**RE: Lincoln Drive Median Access from Mockingbird Lane to the Eastern Town Limits**

## MEMORANDUM

Subject: Lincoln Drive, Mockingbird Lane to Town of Paradise Valley (TOPV) Jurisdiction  
Median Breaks and Access  
Third Party Traffic Review Comments

## Resort Hotel (330)

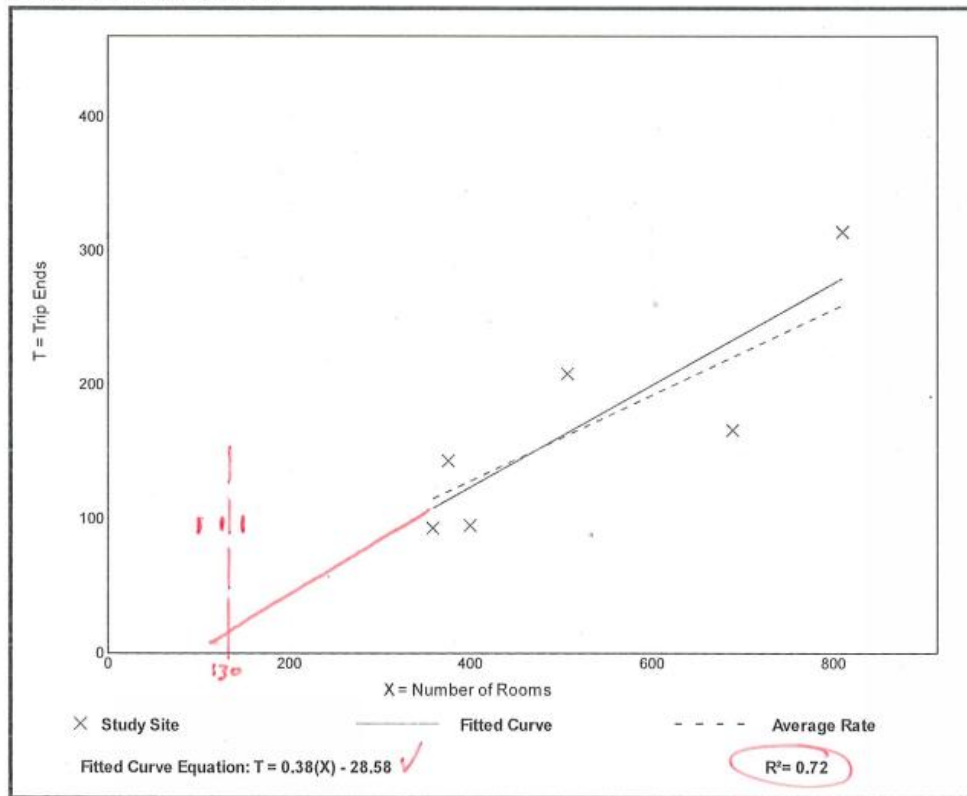
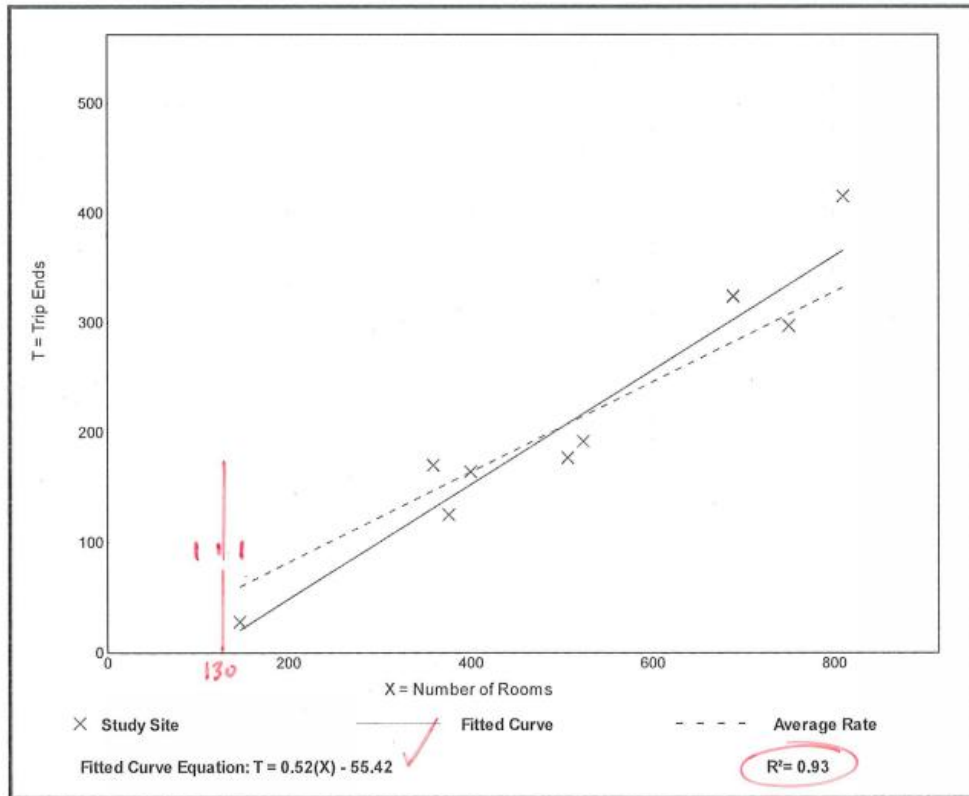
**KH Comments 4:** Smoke Tree Resort utilized equations as opposed to average rates. KHA went through the ITE Trip Generation Handbook process presented in Figure 4.2 assuming proposed number of units for resort hotel (LUC 330). The results of this process are presented below and KH redlines provided in **Appendix 1**.

- The number of rooms is way out of range of the data extremes; the lowest number of rooms in the manual is roughly 370 compared to the 132 that are proposed
- If you follow the equation, which happens to be a straight line and not a logarithmic function, then 132 rooms will generate a very low number of trips
- The number of data points is equal to 6
- The R2 value is close to the required 0.75, so you could argue it either way
- The standard deviation is less than 55% of the average rate

Because the rooms are not within the data extremes and the R2 value is less than 0.75, we recommend the weighted rates be used. Using the rates as opposed to the equation results in double the trips being generated in the AM peak hour.

- The number of rooms is just outside of the data extremes
- The number of data points is greater than 6
- The R2 value is well above the required 0.75
- The standard deviation is less than 55% of the average rate

Because the number of data points and the R2 value are high enough and the standard deviation requirement is met, the use of the equation during the PM peak is appropriate.

**Response to Comment 4:** CivTech has updated the trip generation rates to reflect a blended rate between LUC 310 and 330 as discussed in response to comment #3. The trip generation calculations were also revised to reflect 150 rooms, 30 residential units, and 3500 square foot quality restaurant. The revised trip generation calculations and approach were considered acceptable. The revised trip generation calculations, based on 150 rooms, 30 residential units, and 3500 square foot quality restaurant, are provided in **Appendix 2**.

SHEET  
Opt-01  
01 OF 03

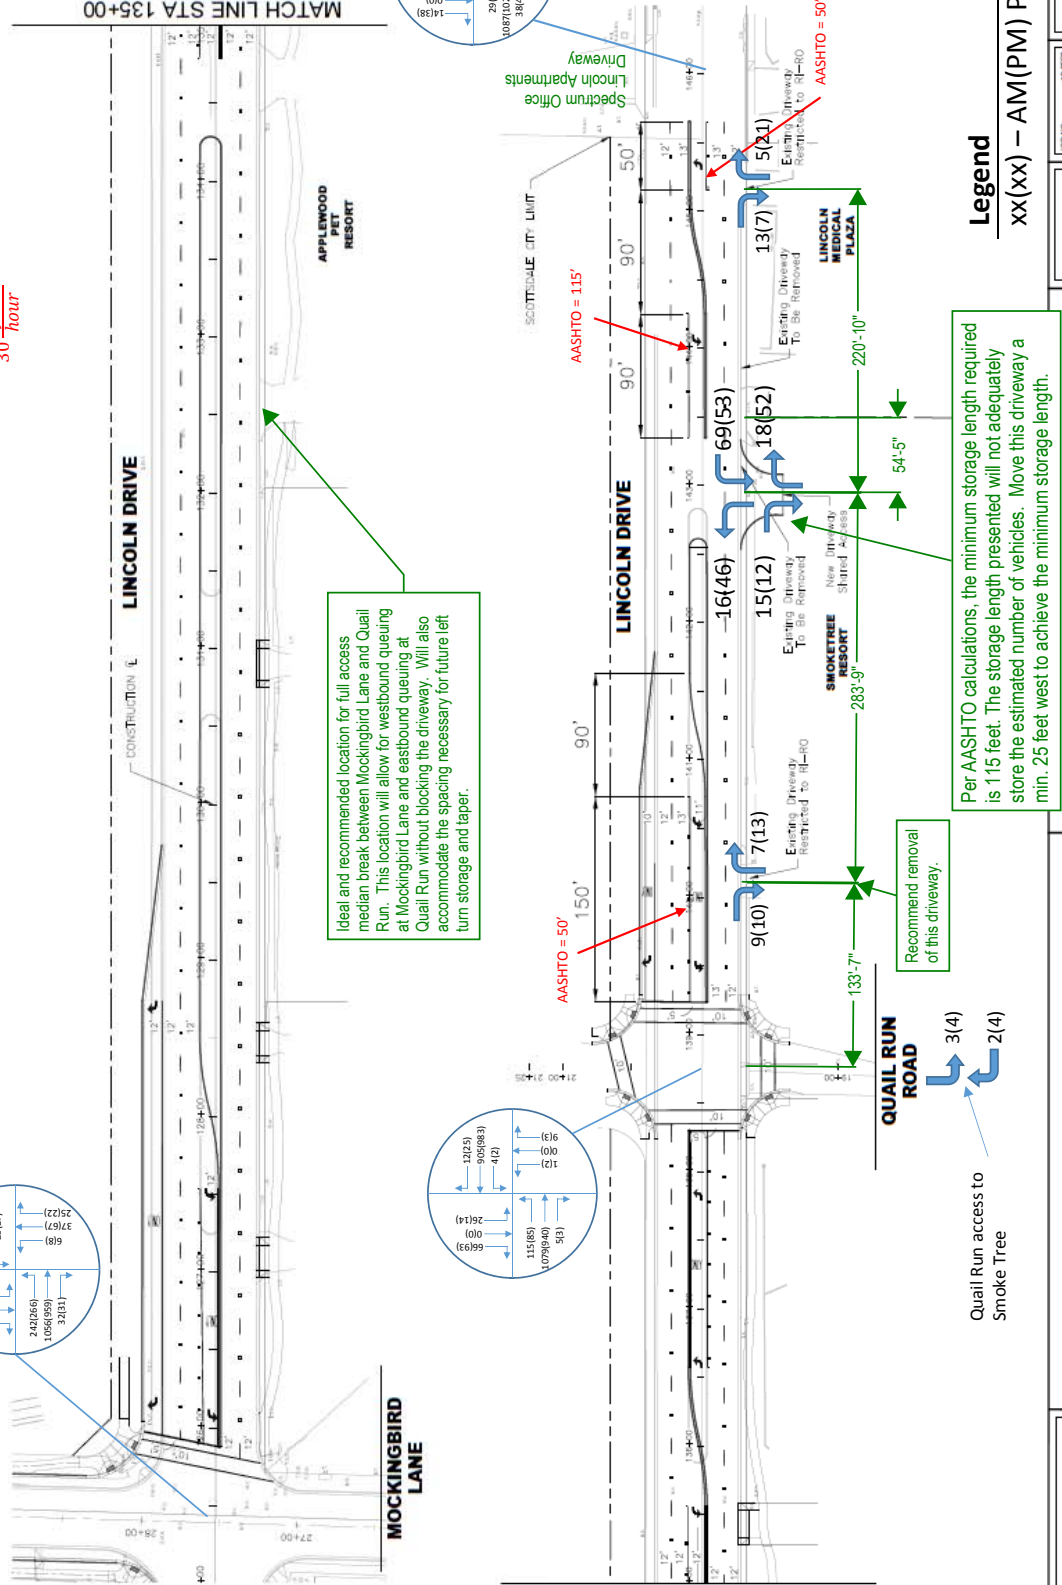
**KH Comment 9:** *This comment applies to all CivTech exhibits prepared. Traffic volumes were not available for the driveways between Mockingbird Lane and Quail Run. In the absence of these volumes, AASHTO A Policy on Geometric Design of Highways and Street (2011), TRB Access Control Manual (2<sup>nd</sup> Edition), City of Scottsdale Design Standards & Policy Manual (2018), and engineering judgement was utilized to comment and make recommendations for full median break recommendations on Lincoln Drive between Mockingbird Lane and Quail Run.*

**KH Comment 10:** Storage length at Spectrum Office Driveway/AJ Driveway calculation ((29 vph x 25 feet x 2)/30) is 48 feet. Per AASHTO, the minimum storage length is 50 feet. Exhibit illustrates a minimum of 50 foot being provided. This is considered acceptable.

**KH Comment 11:** As shown in Option #1 exhibit, access improvements include closure of the existing eastern access on Smoke Tree Resort, a new Smoke Tree Resort access approximately 183 feet west of Lincoln Medical Plaza access, and the existing Smoke Tree Resort western access to remain as right in/right out. The proposed improvements result in the following spacing (centerline to centerline) of driveways:

**KH Comment 12:** The storage length shown in Option #1 exhibit for Lincoln Medical Plaza is 70 feet. Per AASHTO calculations, storage length should be no less than 70 feet to adequately store the estimated number of vehicles generated by Lincoln Medical Plaza. This is considered acceptable. The storage length for the Smoke Tree Resort eastern driveway is 75 feet. Per AASHTO calculations, storage length should be no less than 55 feet to adequately store the estimated number of vehicles generated by the Smoke Tree Resort. This is considered acceptable.

**KH Comment 13:** As shown in Option 1 exhibit prepared by CivTech, opening bay tapers are 40 feet at Smoke Tree Resort and 43-3” feet at Lincoln Medical Plaza. KH recommends that no less than a 90-foot opening taper be utilized to safely traverse traffic from the through lane to the left turn lane on Lincoln Drive, per the criteria and discussion on Page 4, 5, and 6 of this document. Kimley-Horn recommends the median be extended and access points to Lincoln Medical Plaza be restricted to right in/right out only movements for two reasons:

Ideal and recommended location for full access median break between Mockingbird Lane and Quail Run. This location will allow for westbound queuing at Mockingbird Lane and eastbound queuing at Quail Run without blocking the driveway. Will also accommodate the spacing necessary for future left turn storage and taper.

SHEET  
Opt-02  
02 OF 03

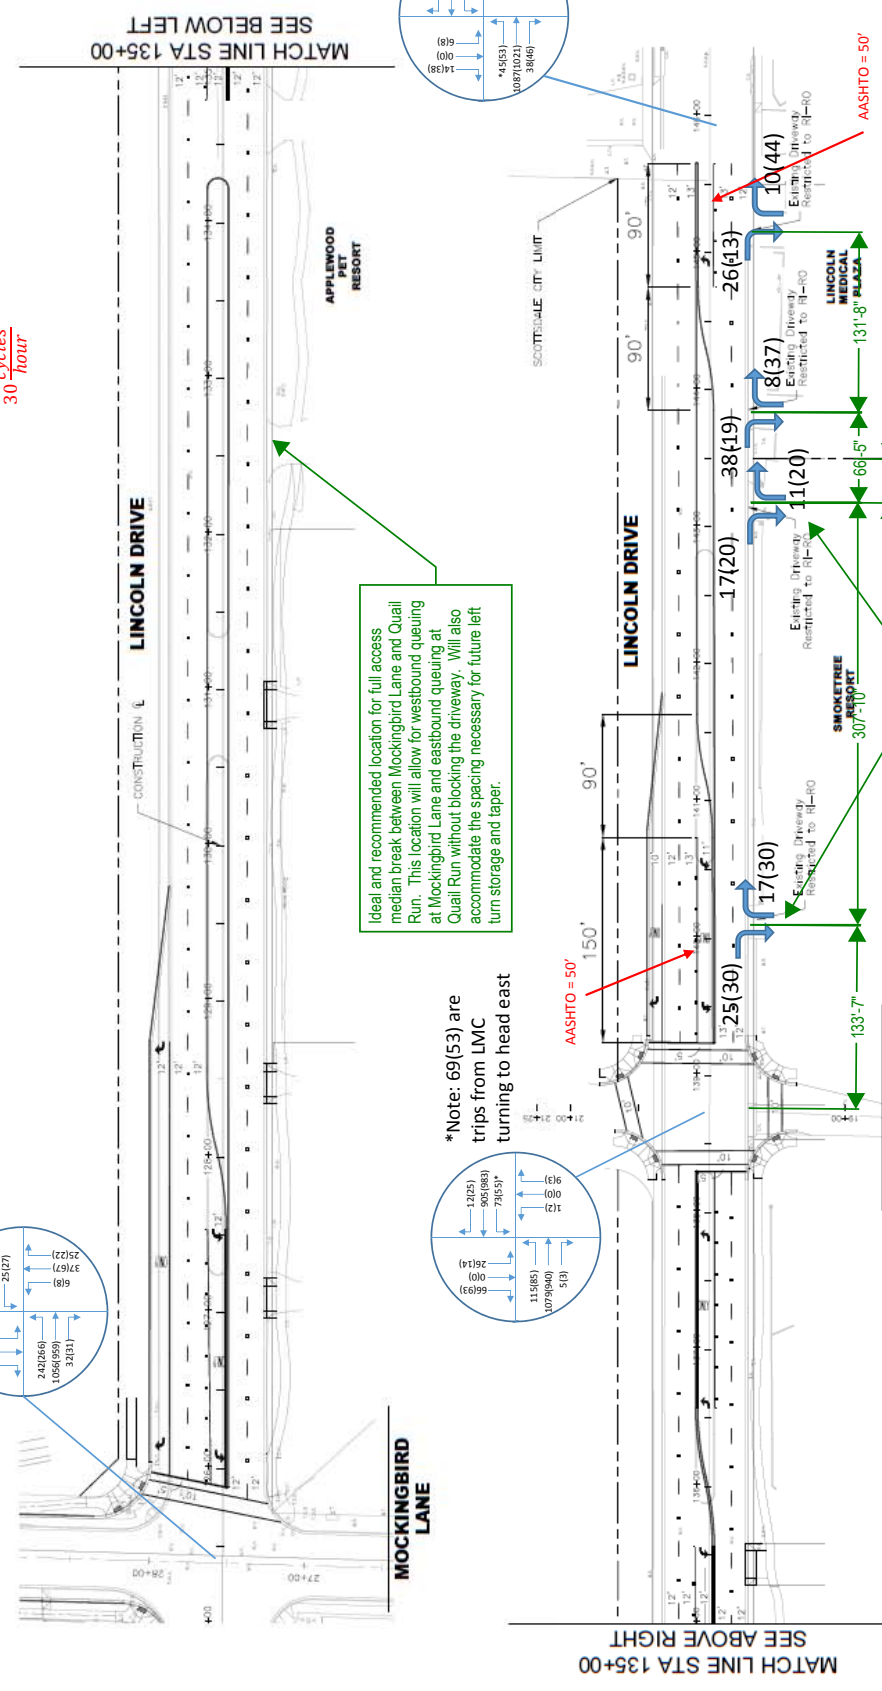
**KH Comment 14:** As shown in Option #2 exhibit, access improvements include closure of the western Lincoln Medical Plaza access, a new shared access for the Smoke Tree Resort / Lincoln Medical Plaza approximately 55 feet from the shared Smoke Tree Resort / Lincoln Medical Plaza parcel line, and right in/right out to all other access points between Quail Run and TOPV jurisdictional boundary line. The proposed improvements in this option result in the following spacing (centerline to centerline) of driveways:

**KH Comment 15:** As shown in Option 2 exhibit prepared by CivTech, opening bay taper to the shared Smoke Tree Resort and Lincoln Medical Plaza is 90 feet. This is considered adequate.

**KH Comment 16:** The storage length shown in Option #2 exhibit for the shared Smoke Tree Resort/Lincoln Medical Plaza access is proposed at 90 feet. Per AASHTO calculations, storage length should be no less than 115 feet to adequately store the estimated number of vehicles generated by

*Smoke Tree Resort and Lincoln Medical Plaza. For this option, the shared access should move a minimum of 25 feet west of the location shown in the CivTech exhibit to accommodate the minimum storage length necessary to adequately store the estimated left turn volumes without spilling back into Lincoln Drive through lanes. This would result in placing the shared driveway a minimum of 80 feet from the Smoke Tree resort/Lincoln Medical Plaza parcel line.*
